White Rock Solar Farm SSD 16_7487

Proponents Response to Submissions

Document No. WR-PM-REP-0002

Figure 1.1 White Rock Solar Farm – Indicative Project Layout

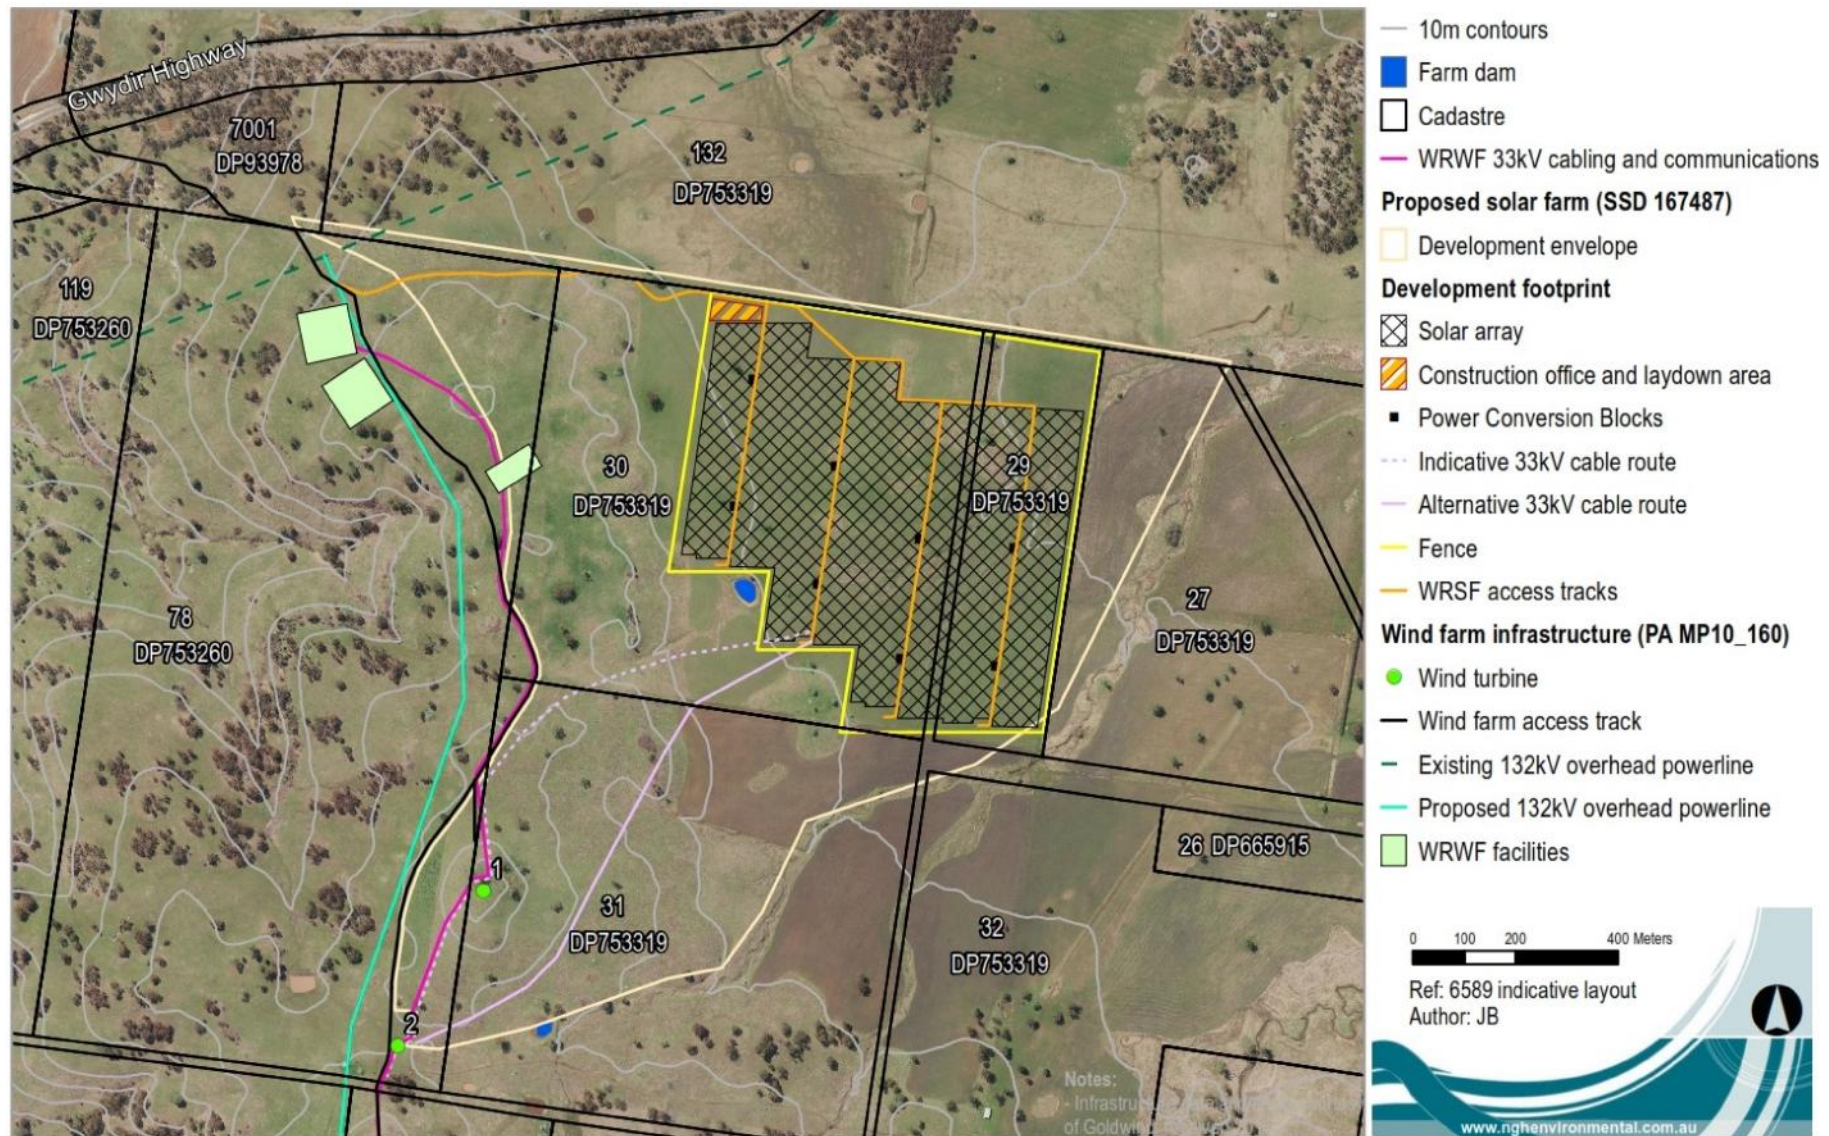
- a breakdown of the vegetation clearing required for the access tracks, the 33 kV cable, and the PV arrays.
- an alternative layout for the PV array that minimises vegetation clearing to the maximum extent practicable;
- a revised constraints map that includes (in addition to the existing information):
 - the two closest residences (I40 and H40);
 - the buffer zones around the proposed 33kV cable routes and access tracks;
 - any features that restrict the re-arrangement of the PV array (e.g. lands reserved by the landowner for cropping, and the stock watering infrastructure in the south of the site).

- DPE sought “a breakdown of the vegetation required for the access tracks, the 33kV cable and the PV arrays”. DPE also sought a revised constraints map including buffer zones around the proposed 33kV cable routes and access tracks. The vegetation impact calculations provided by NGH to address the DPE request and included in this report, allow for the buffers (Appendix B)
- OEH recommended that “Consideration should be given to reducing the impact of the project on the low condition Endangered Ecological Community (EEC) occurring on the site by reconfiguring the development layout, where possible.”
- Additionally, DPE requested that WRSFPL provide; “an alternative layout for the PV array that minimises vegetation clearing to the maximum extent practicable”.

Figure 1.1 shows the current form of the proposed WRSF layout on which assessments in this report are based. However, while a contractor has been selected, the final details of the design are still to be confirmed and WRSFPL recognizes that some adjustments to the layout may still be needed to achieve a practical and compliant layout. Nevertheless, WRSFPL believes that there is potential to vary details of the design without significantly changing the environmental outcomes. WRSFPL seeks a Development Consent that allows some flexibility in layout and design while ensuring environmental objectives are met.

The indicative layout in Figure 1.1 also assumes that access is obtained from DPI-Lands for placing solar panels across the Crown Road between Lots 29 and 30.

Overall, the extent of the final design solar array footprint is expected to be less than is shown in Figure 1.1 and as mentioned in this report does not require clearing of the land where the solar panels are located. Vegetation impacts shown in this report are considered to over-state the impact.

The assessment of landscape and visual amenity in the WRSF EIS was based on the layout provided in Figure 4.1 of the WRSF EIS. The revised layout shown in Figure 1.1 has varied from that in Figure 4.1 of the EIS but is not regarded as warranting further visual assessment. Differences in layout are shown below as a guide to the minor changes expected for visual impact.

- The solar panels remain in the same paddock as for the WRSF EIS Figure 4.1;
- There has been a slight contraction of the northern extent of solar panels to the south which is away from the likely viewpoints of the neighbouring landowners access driveway and the Gwydir Highway;
- The southern extent of the Solar Farm has in part moved further to the south; and
- The solar panels may be continuous across a crown road that was previously avoided as shown in Figure 4.1 of the WRSF EIS.

Figure 3.2 – Watercourse Cross Sections (CL-1, CL-2 and CL-4) at WRSF Site

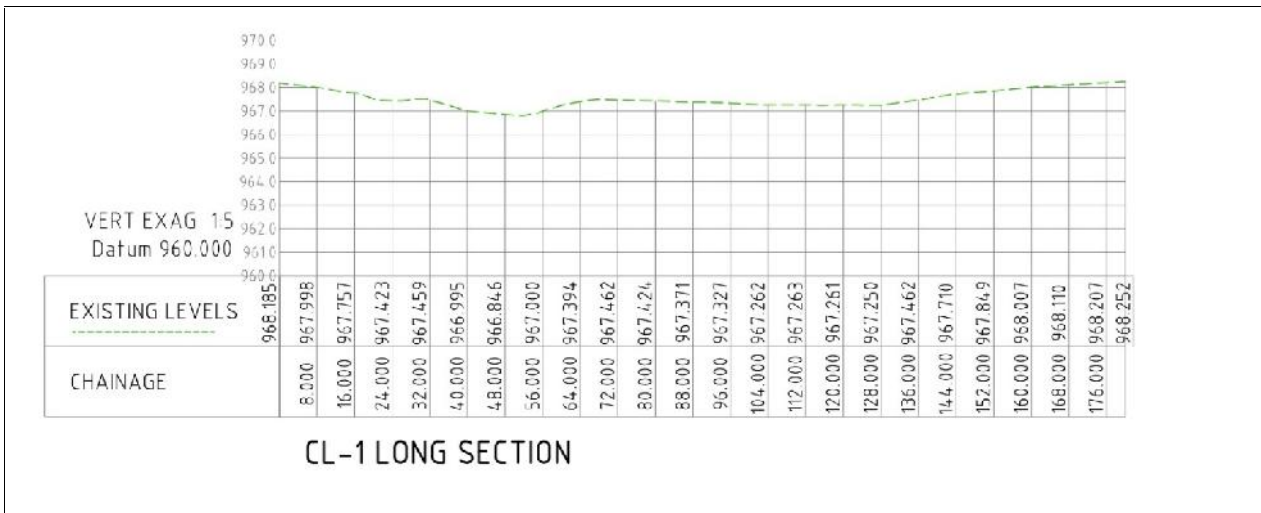
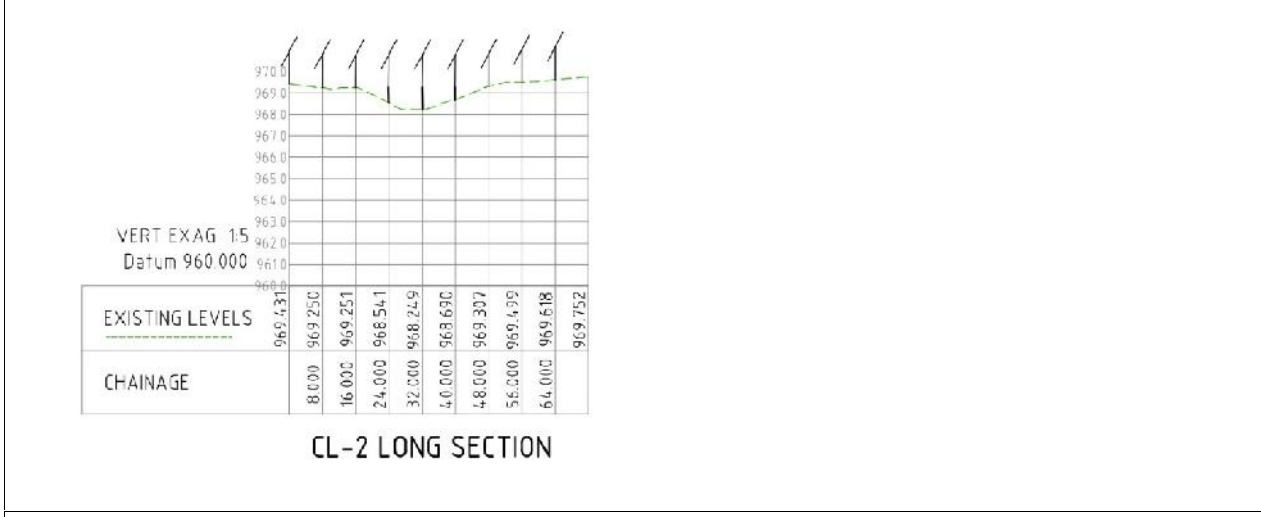
Additionally, in response to DPI-Water's request, WRSFPL engaged the contractor to provide more detailed mapping for the WRSF site and, sections along and across the watercourses. The mapping and sections are shown in Appendix C. Details of the sections prepared are shown in Table 3.2. The cross sections are also shown in Figure 3.2.

There are two watercourses present at the WRSF site (Appendix C). These are shallow ephemeral watercourses trending generally southwest to northeast. The watercourses are within the upper part of the Wellingrove Creek catchment and are First Order watercourses. As evident in Figure 3.1, the watercourses are wide shallow features (see also data in Table 3.2). A photo of a section of the deeper northern watercourse is shown in Plate 3.1. It can be seen in the photo that the watercourse is a shallow depression, is well vegetated and is crossed by an existing fence.
